Project Title
Proposed Retirement Housing
Bolton Road
Banbury
OX16 0TH

Drawing Title
PROPOSED NORTH BAR STREET ELEVATION
PLANNING APPLICATION

Scale 1:100 / 200 @ A1 Date DEC. 2021
Drawn KLS Checked RJ
Drawing No. Rev.
10116BB - PA08 B

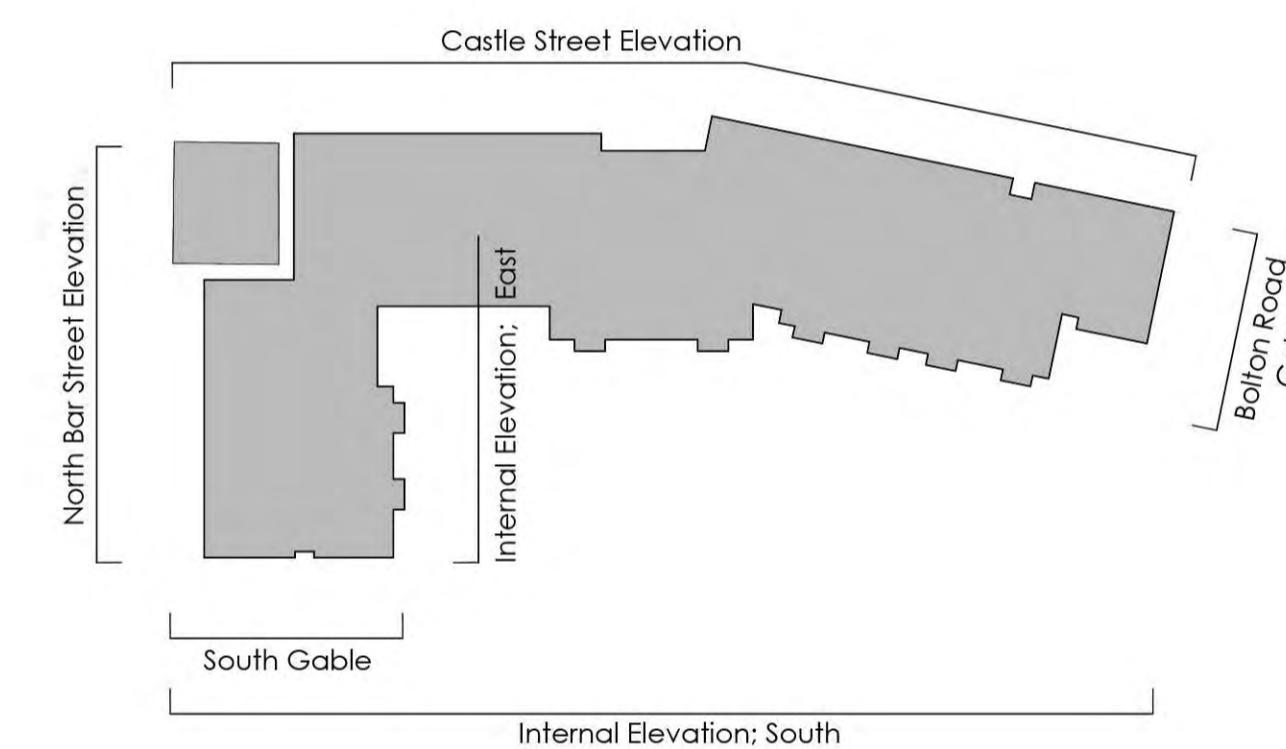
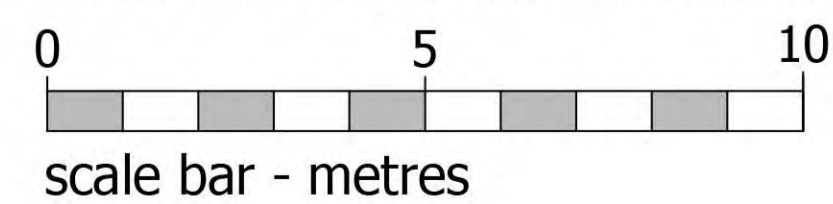
A Drawing number amended.
 B Stair 2 relocated centrally within proposed scheme.
 Flats 06-09, 27-30, 55-58 relocated towards Trelawn House.
 Lift core adj. to Stair 1 previous position terminated at second floor level; corridor omitted behind Trelawn House roofline. Roof hipped adjacent to Trelawn House.
